CR234 – ABS Control Unit Software Update and IMU Sensor Correct Assembly Check

Desert X MY2023 (USA country versions only)
Technical Service Bulletin SRV-TSB-22-009

Date: August 2, 2022
To: Dealer Principal, General Manager, Service Manager, North American Dealer Network
From: Richard Kenton, Technical Director
Dan Schwartz, Service Area Manager

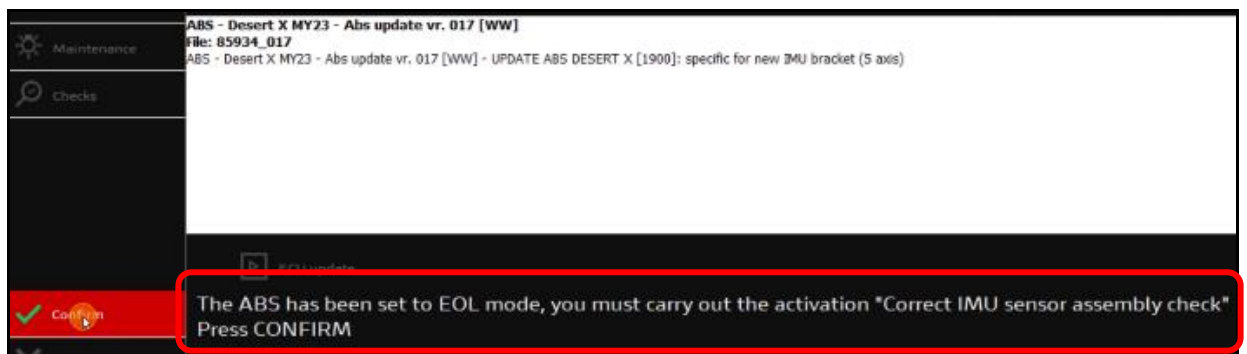
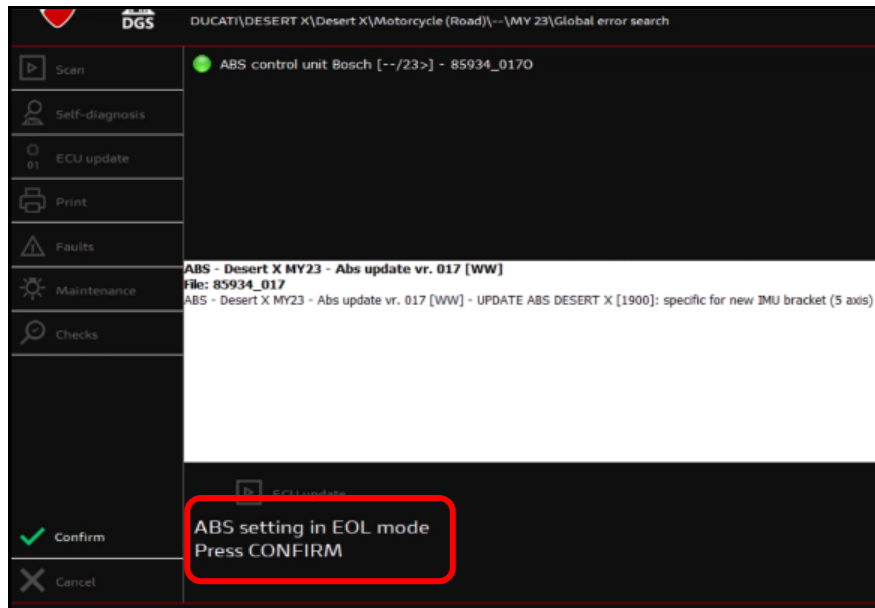
1. Connect the workshop power supply unit to the vehicle, switch it on (checking that the charge warning light comes on correctly) and perform a key ON.
2. Connect the DDS 3.0 diagnosis instrument to the power supply unit and run a **Global Scan** which will show a forced update for the ABS control unit (Software Version **85934_017**).

3. After the ABS control unit update, the DDS 3.0 will automatically set the ABS to EOL mode and inform you that the correct IMU sensor assembly check is required ("**Correct IMU sensor assembly check**").

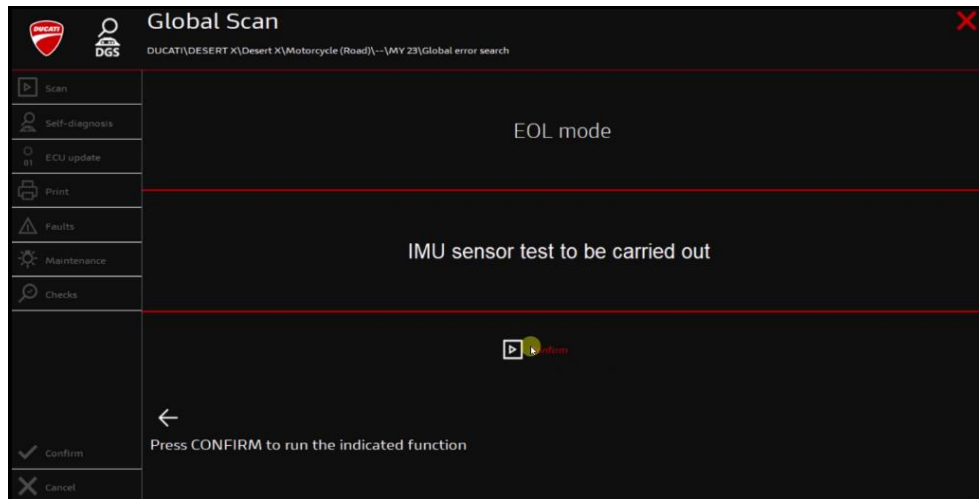
4. Upon the next **Global Scan**, the DDS 3.0 will guide you through the procedure for checking the IMU sensor correct assembly.

To carry out this check, the motorcycle must be placed on the center or rear paddock stand.

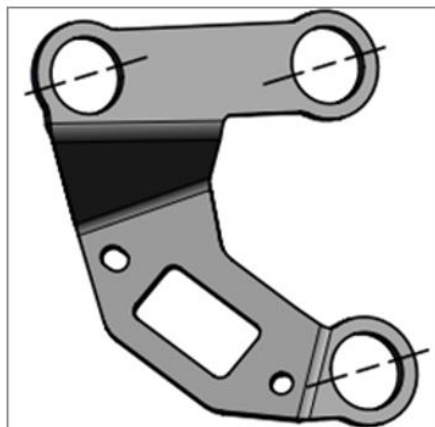
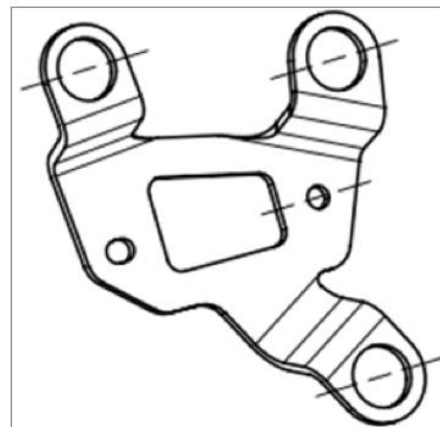
5. At the end of the procedure, if the test outcome was successful, the DDS 3.0 will suggest you run a new **Global Scan** and will finally ask you to remove the *"Transport Mode"* function. After the *"Transport Mode"* has been removed, an error deletion procedure must be carried out.
6. If the test ends with errors, you must:
 - a. Access *"ABS Diagnosis"* select the *"Settings"* window and click on *"ABS setting in EOL mode"*. Then set the ABS control unit in EOL mode
 - b. Check that the software version of the ABS control unit is the correct, in *Info ECU ABS*, field *BB number (algorithm) = 85934*
 - c. Check the shape of the IMU sensor Support Bracket to confirm part number is **8301B191BA**

Correct IMU Support Bracket
8301B191BA

Incorrect IMU Support Bracket
8301B181AA
